Access Compliance Report

Public Rights-of-Way

(Pedestrian Signals)

Intersection ID: N/A	Main Street:	Cross Street: N/A	Location: N/A
ADA ID: 17EE186F35F9	Signal Type: One Push Button-Non APS	Overall Compliance: No	Severity Score: BTN 1: N/A BTN 2: N/A No BTN: N/A
Codes/Mitigation Info/Possible Solution		Field Measurements/Component Compliance

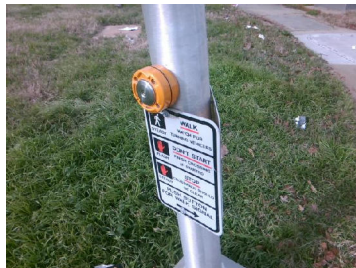
PROW/ADA: TMUTCD 4e.08, R404.3, R404.7.3

Yes	B 1 Clear Xing Direction?	ClearlyMarked	N/A	B 2 Clear Xing Direction?	N/A
	B 1 Crossing Direction	To NE		B 2 Crossing Direction	N/A
Yes	B 1 DistanceTo XWalk (in)	0.0	N/A	B 2 DistanceTo XWalk (in)	N/A
No	B 1 DistanceTo Curb (in)	137.0	N/A	B 2 DistanceTo Curb (in)	N/A
Yes	B 1 Diameter (in)	2.0	N/A	B 2 Diameter (in)	N/A

Possible Solutions: Replace Signal Push Button With APS Button on New Post. Remove & Relocate Sign.
